RE: **41-DR-2024**
5th & Goldwater Mixed-Use
12U16 (Key Code)

Planning & Development Services has completed review of the above referenced development application resubmitted on 5/21/2025. The following comments represent issues or deficiencies identified by the review team and are intended to provide you with guidance for compliance with city codes, policies, and guidelines.

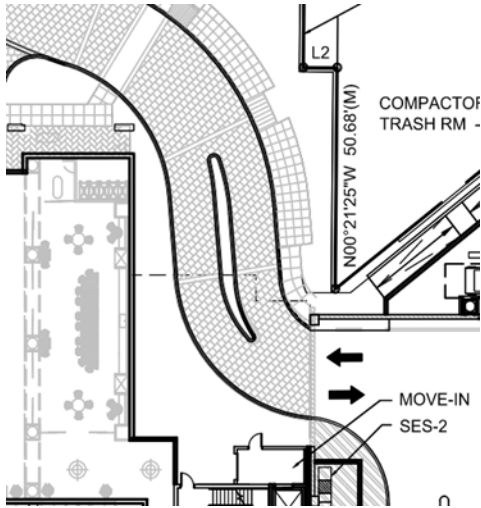
6. Though a "bus stop" is now indicated on the site plan, Stipulation #10 from case 12-ZN-2007 specifically states a transit shelter is to be provided over the existing bus stop. Please revise the site plan to indicate "New Transit Shelter". Also note the shelter type recommended by the Transportation Department, which is the DS-2263 shelter with amenities.
7. From 1st review, please add the allowed/provided density with calculations to the site plan. Acknowledged in the response letter but needs to be on the plan as the site plan is what the case will be stipulated to.
8. The 1st submittal site plan did a good job of "fading" the floor plans into the background, making the site plan easier to read. On the 2nd version site plan, the floor plans are in bold, making the

site plan more difficult to interpret. Please revise the site plan to minimize the floor plans or eliminate floor plans altogether.

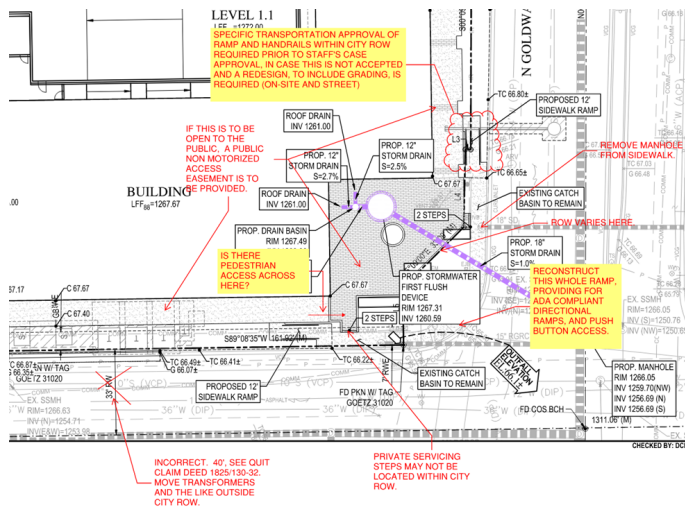
9. **From 1st review, please provide turning radius template for AASHTO Single Unit Truck and ensure all fire access requirements are met at the location below.**
